## **Management Control Program 5.2**

**POWERTECH (USA) INC.**

**TR Section 5.2**

Figure 5.7-2: Locations of Exposure Rate Monitors on-site of Satellite Facility, Outside the Satellite Facility

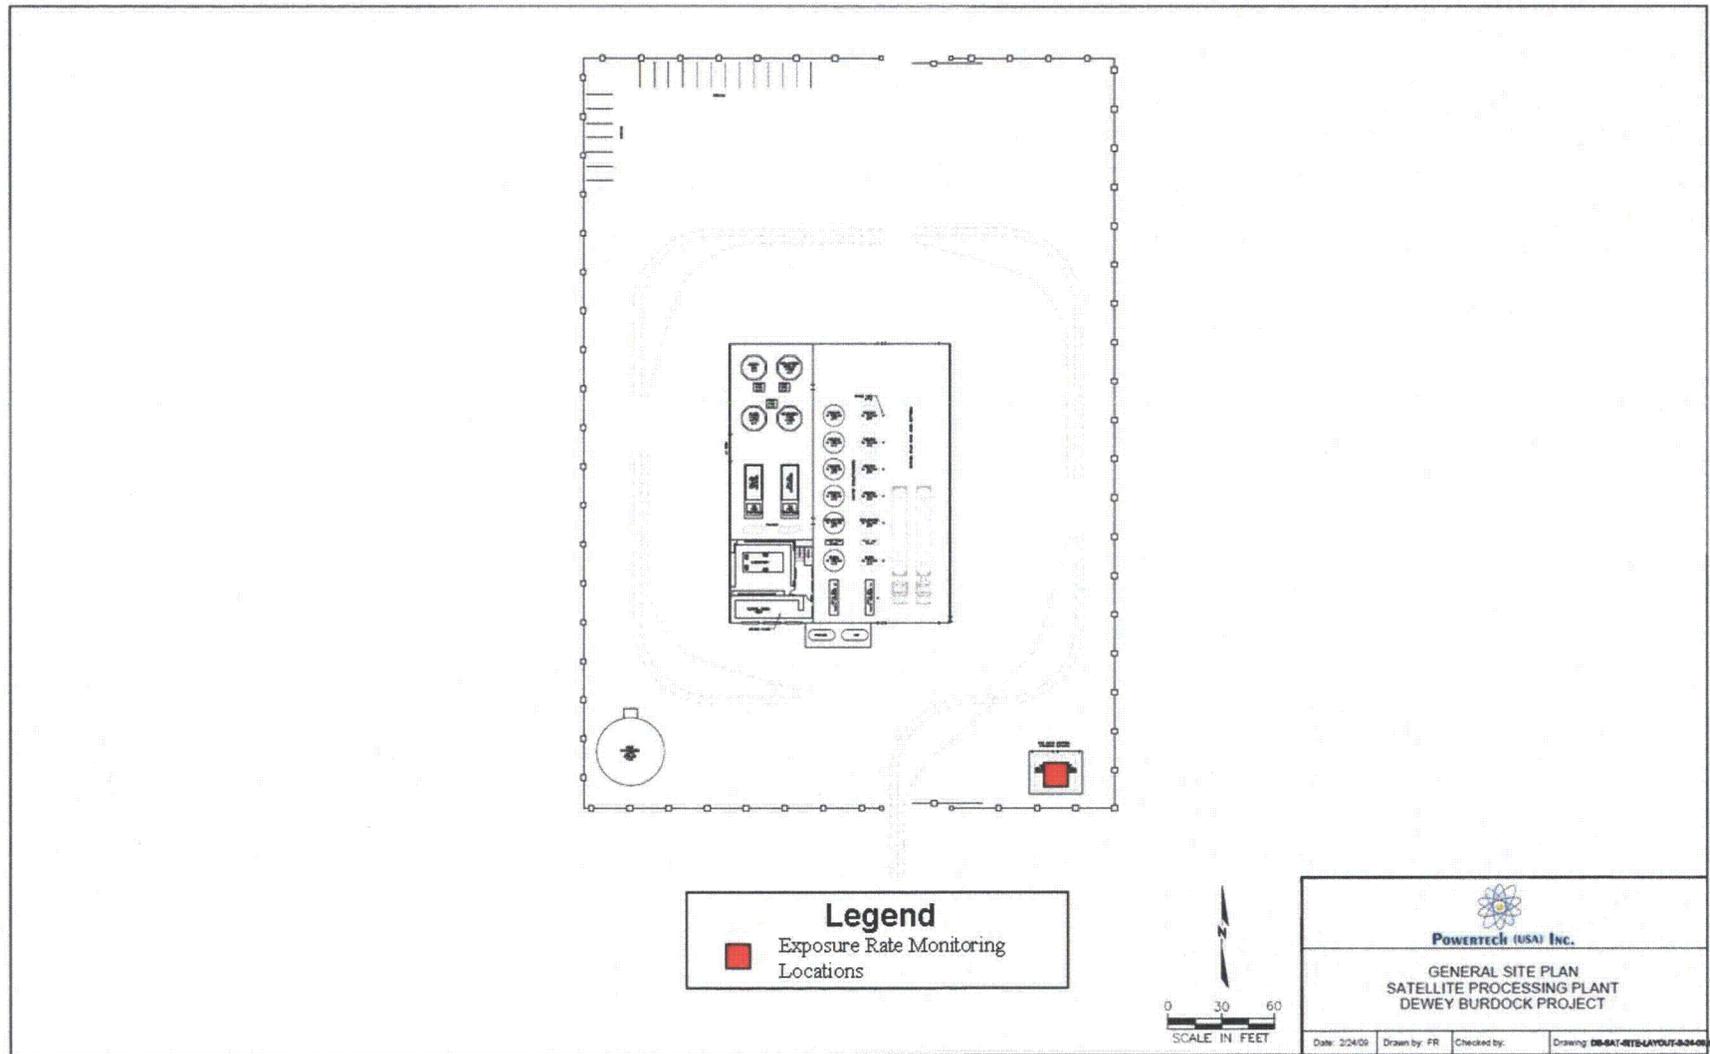
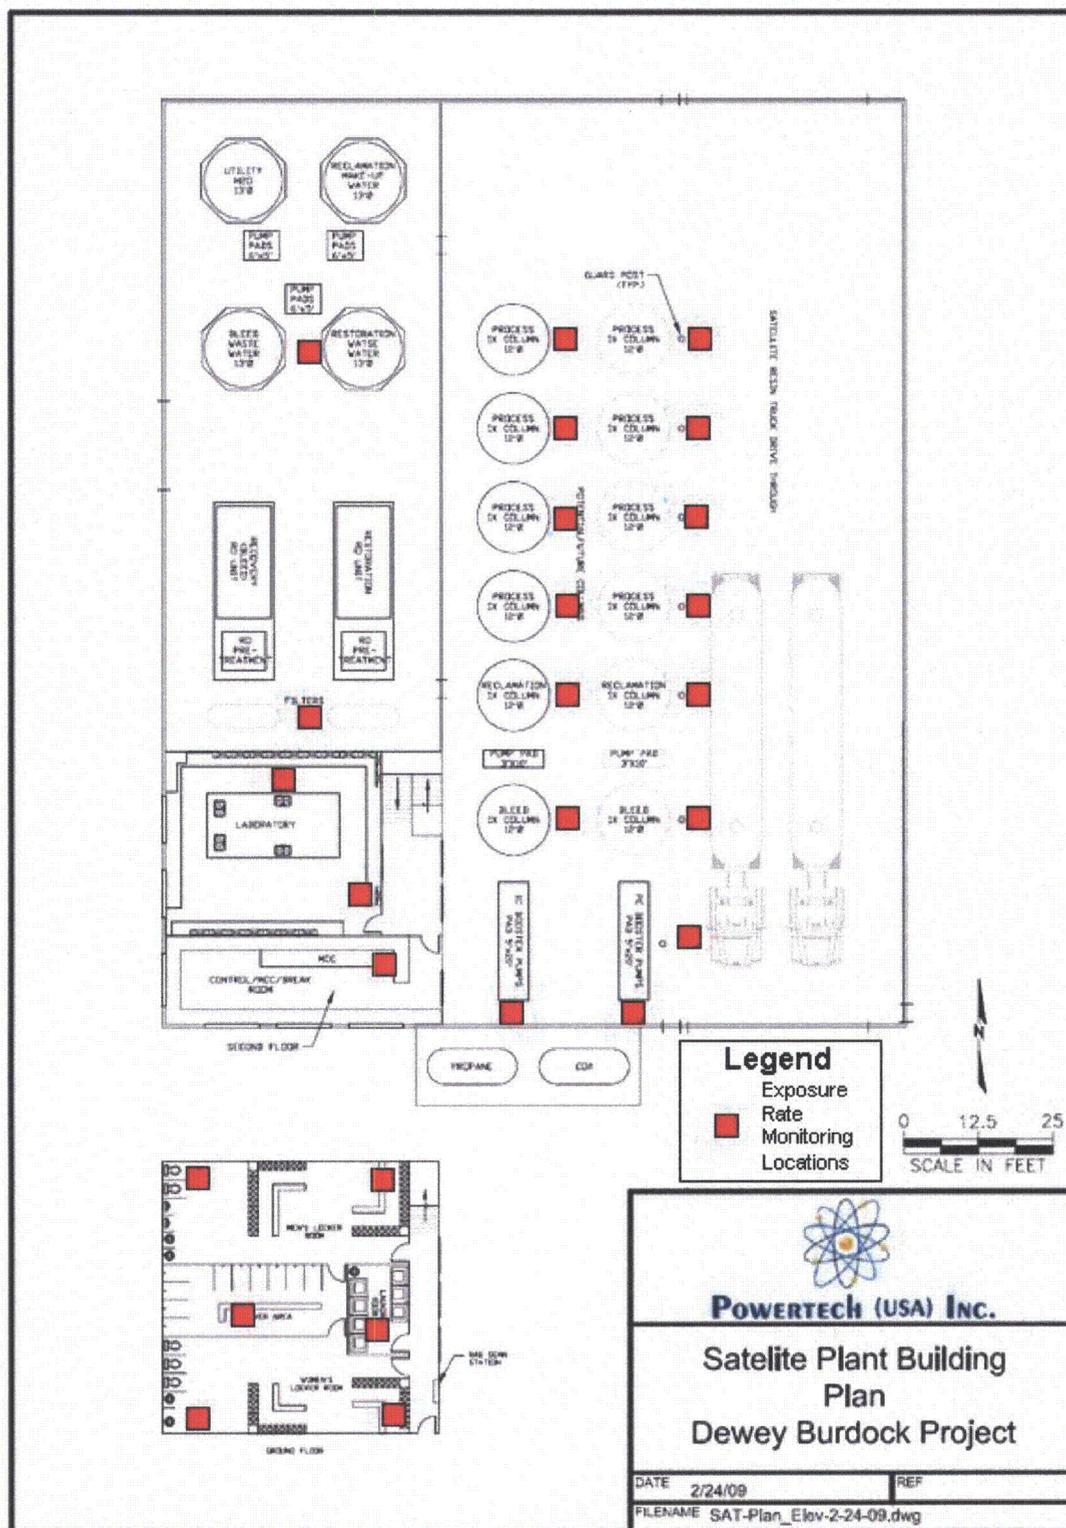
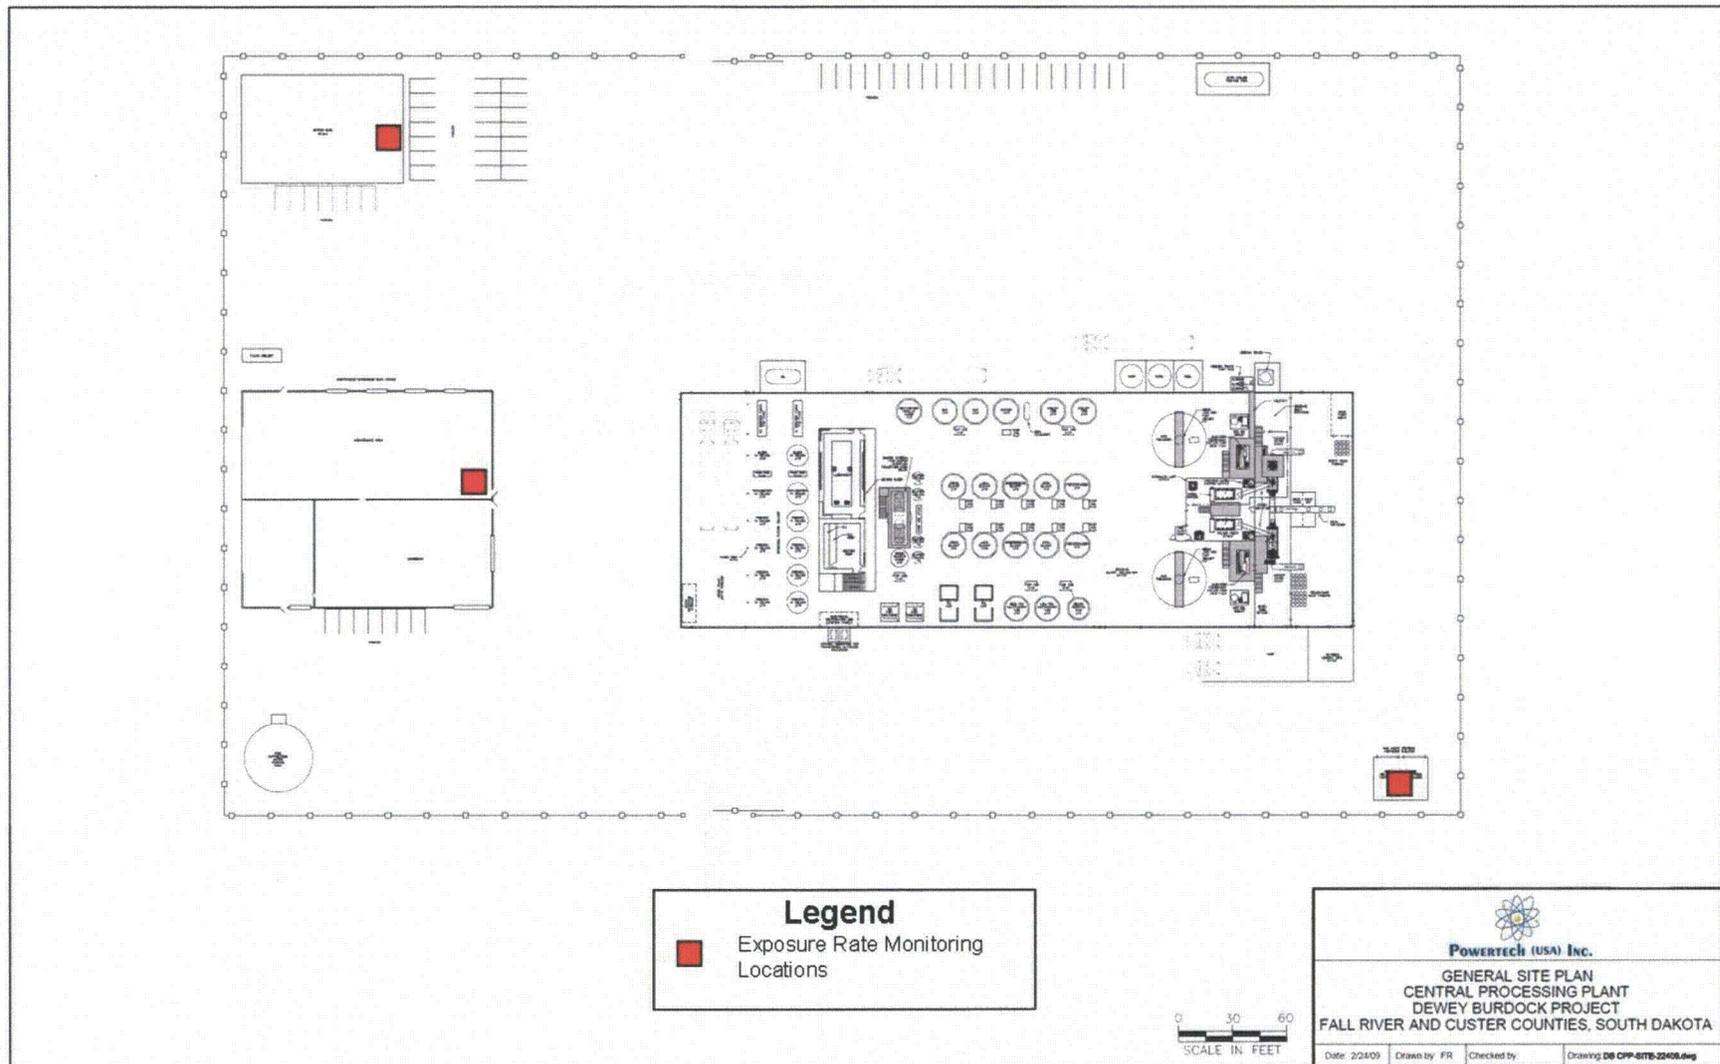
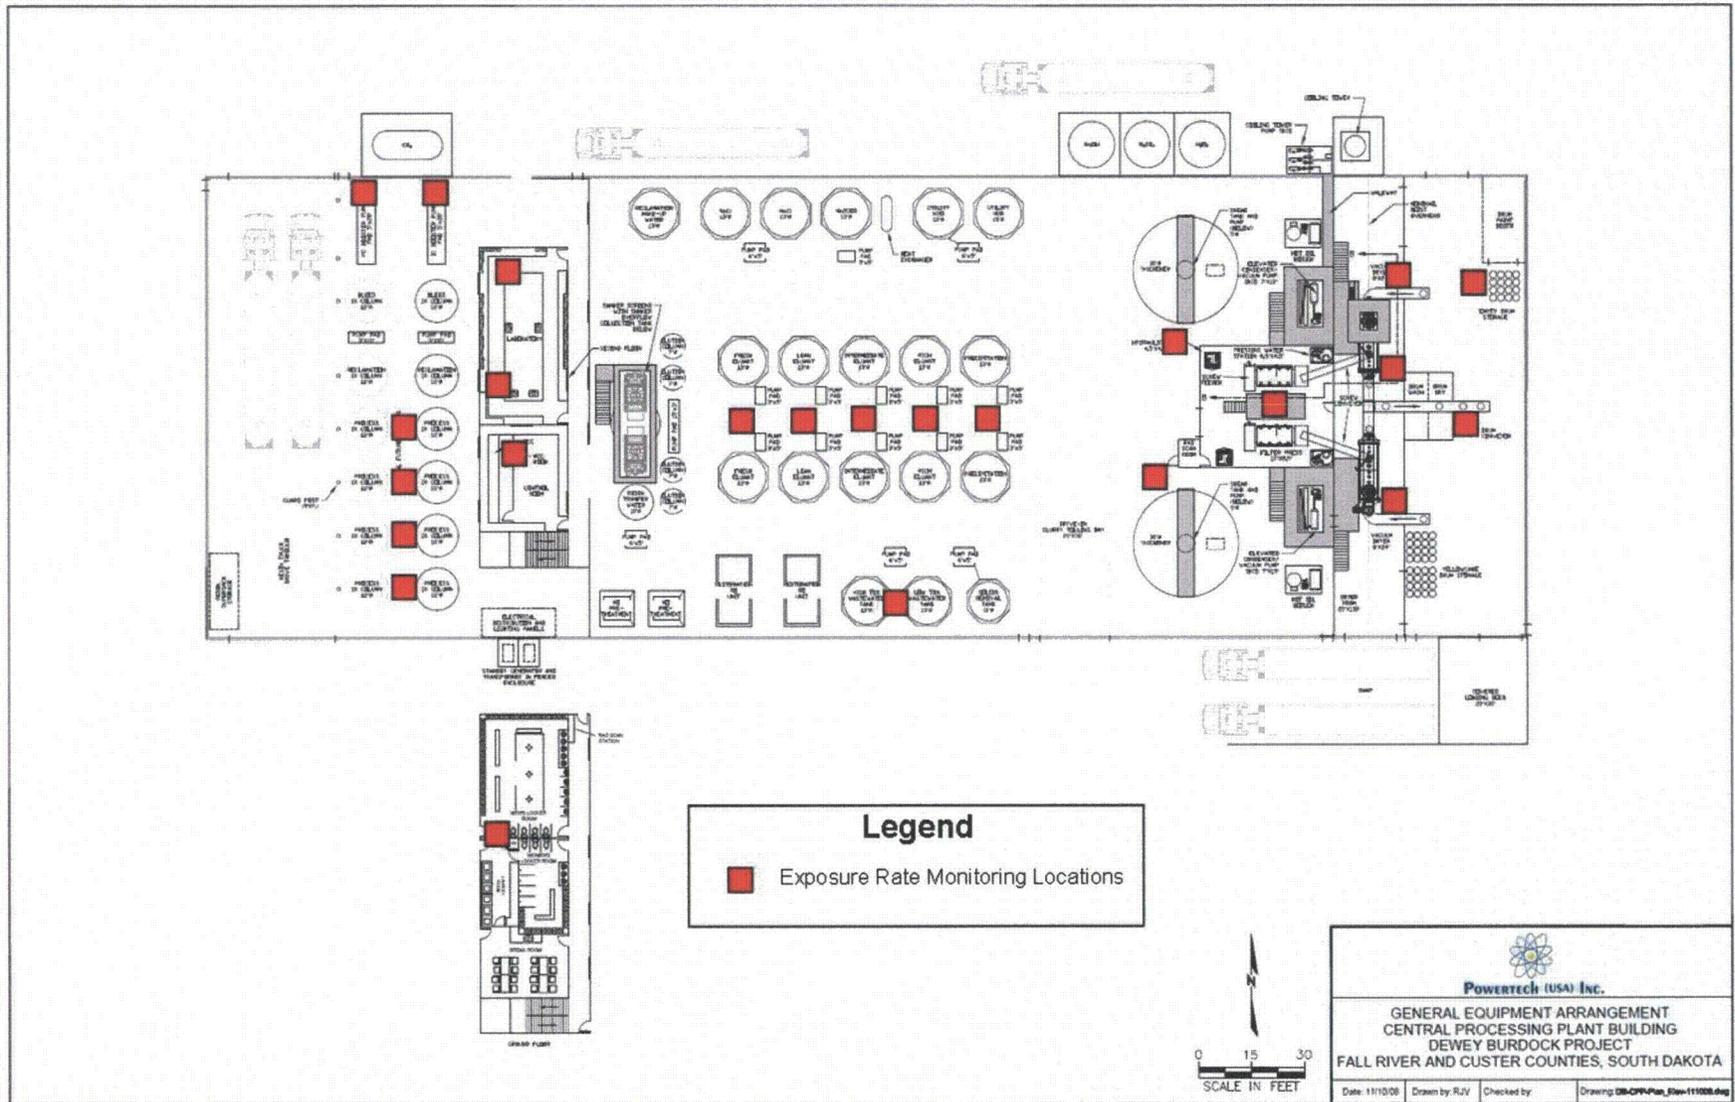
*Section 5.7.2.1 refers to Figure 5.7-1 for the locations of fixed radiation exposure measurements at the Dewey-Burdock facility. However, Figure 5.7-1 depicts the proposed operational environmental monitoring sites. Please provide the correct figure reference(s).*

**Response TR RAI-5.7.2-5**

Figure 5.7-11: Operational Environmental Monitoring Sites

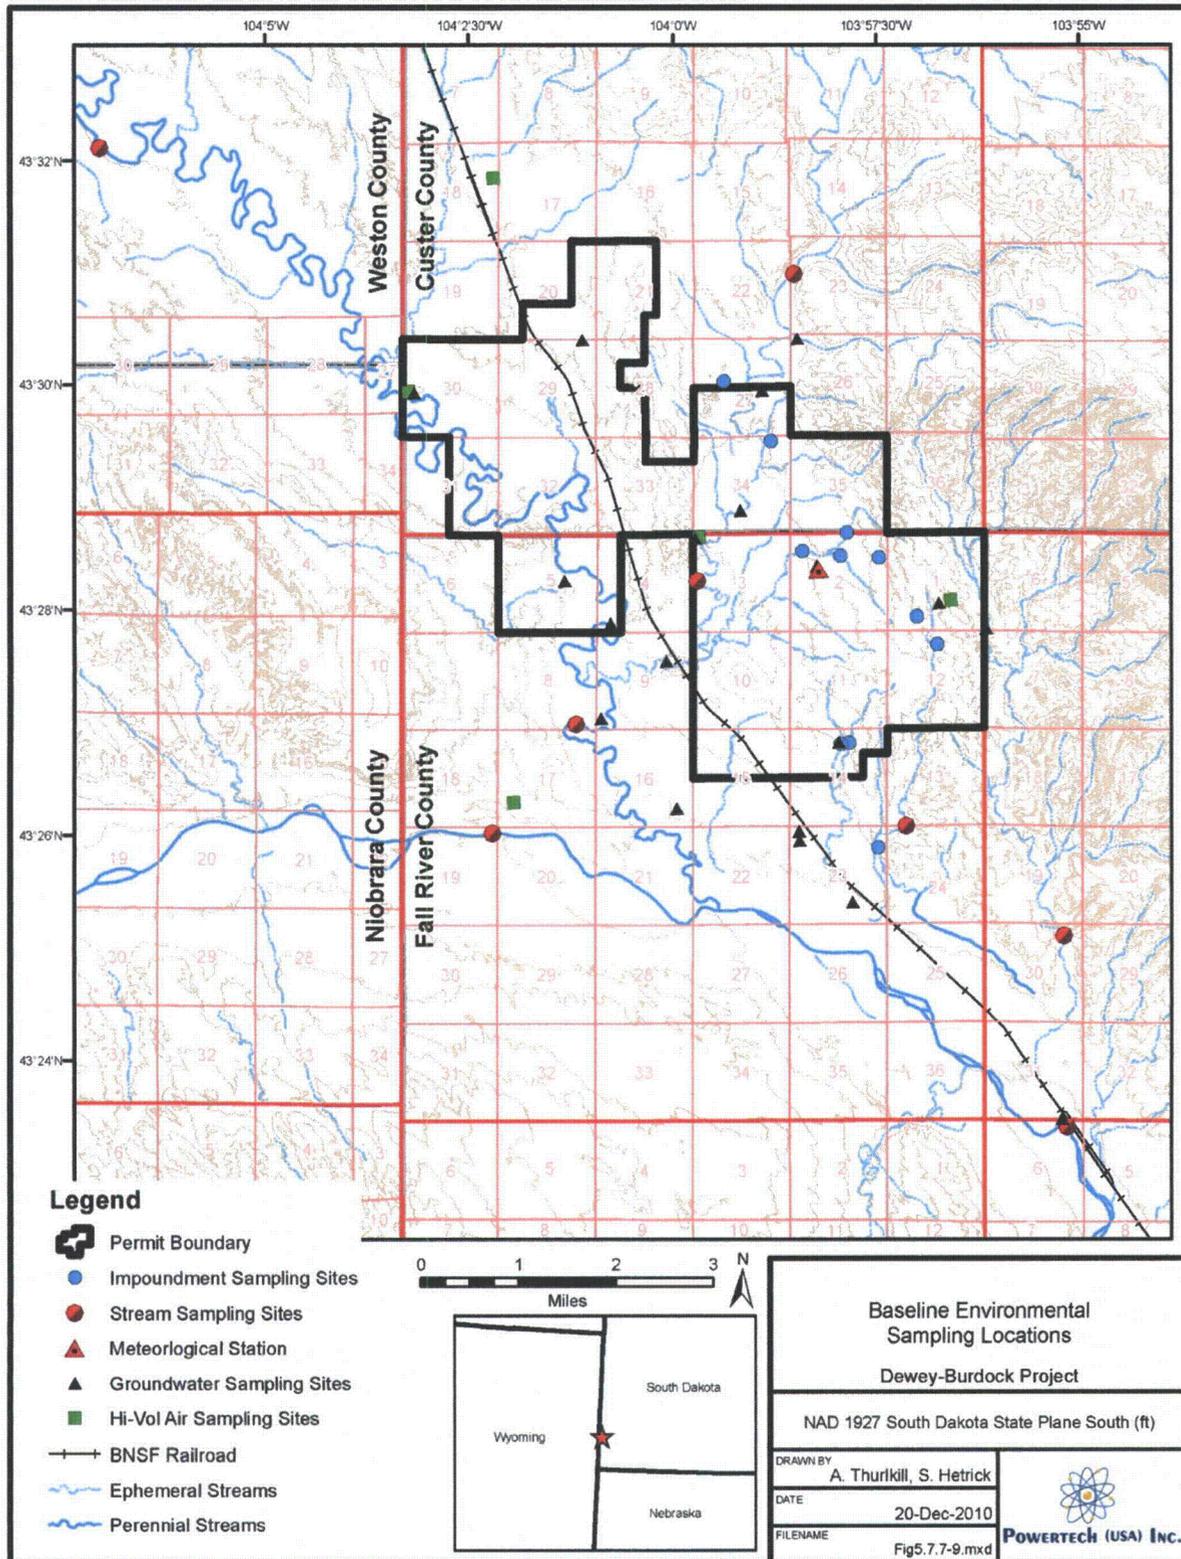
***In Section 2.7.3.1 of the TR the applicant identified 48 surface water impoundments. However, in Section 5.7.8 of the TR, the applicant identified only 11 impoundments in its operational surface water monitoring program as shown on Figure 5.7-10 of the TR.***

See TR\_RAI-Response Response 5.7.8-9 for (Figure 5.7-11) the scale of the map has been adjusted to depict all surface water sampling locations upstream of PAA and downstream of PAA.
